HISTORIC AND DESIGN REVIEW COMMISSION

August 07, 2019

HDRC CASE NO: 2019-322
ADDRESS: 648 LEIGH ST
LEGAL DESCRIPTION: NCB 2739 BLK LOT A15
ZONING: R-5,H
CITY COUNCIL DIST.: 1
DISTRICT: Lavaca Historic District
APPLICANT: JENNIFER BARRAR/BOBO CUSTOM BUILDERS
OWNER: LATASHA DUNN/DUNN LATASHA
TYPE OF WORK: Window replacement
APPLICATION RECEIVED: July 19, 2019
60-DAY REVIEW: September 17, 2019
CASE MANAGER: Stephanie Phillips
REQUEST:

The applicant is requesting a Certificate of Appropriateness for approval to replace seventeen (17) one over one wood windows with new wood windows. The applicant previously agreed to repair all the windows at the June 24, 2019, HDRC hearing, but has provided new evidence in an effort to substantiate the need for full replacement.

WINDOW TYPE 1

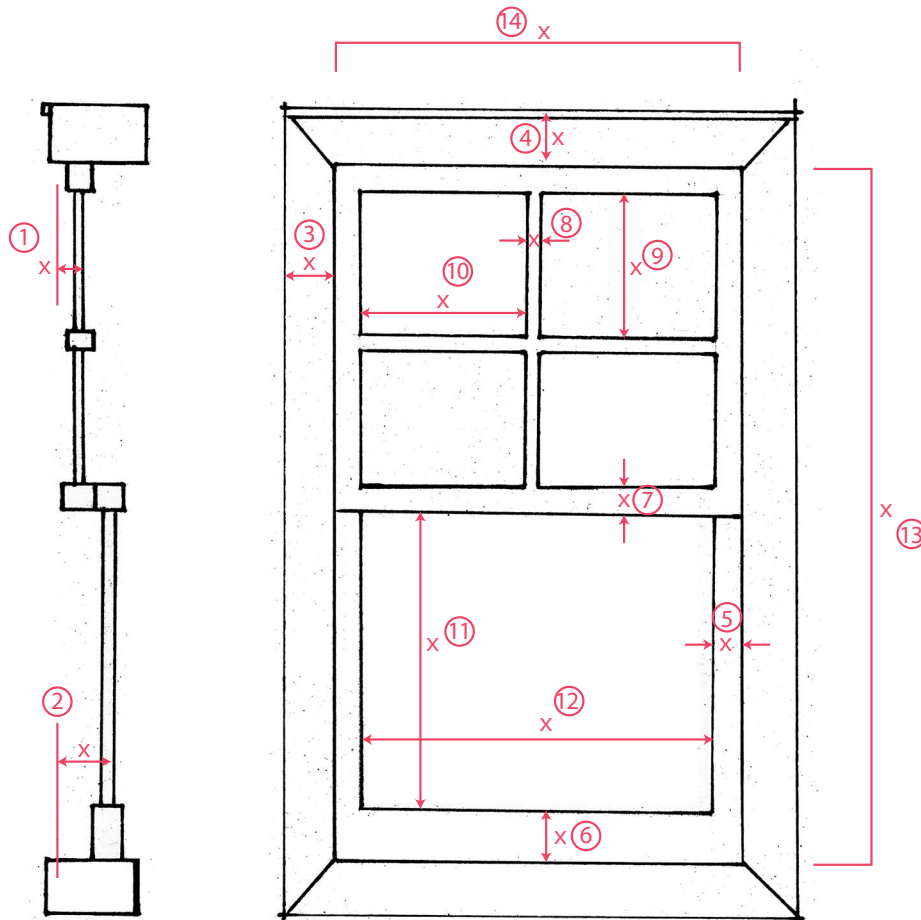
- e. WINDOW REPLACEMENT – According to the Guidelines for Exterior Maintenance and Alterations 6.A.iii., and 6.B.iv., in kind replacement of windows is only appropriate when the original windows are beyond repair. Based on the new information provided, staff does not find the windows to be unrepairable. Replacement of any kind is not consistent with the Guidelines.

- i. That the applicant installs one-over-one fully wood windows to match the existing configuration as closely as possible. The proposed replacement product is not appropriate. Meeting rails must be no taller than 1.25” and stiles no wider than 2.25”. There should be a minimum of two inches in depth between the front face of the window trim and the front face of the top window sash. This must be accomplished by recessing the window sufficiently within the opening or with the installation of additional window trim to add thickness. The final specification should be submitted to staff for review prior to the issuance of a Certificate of Appropriateness.
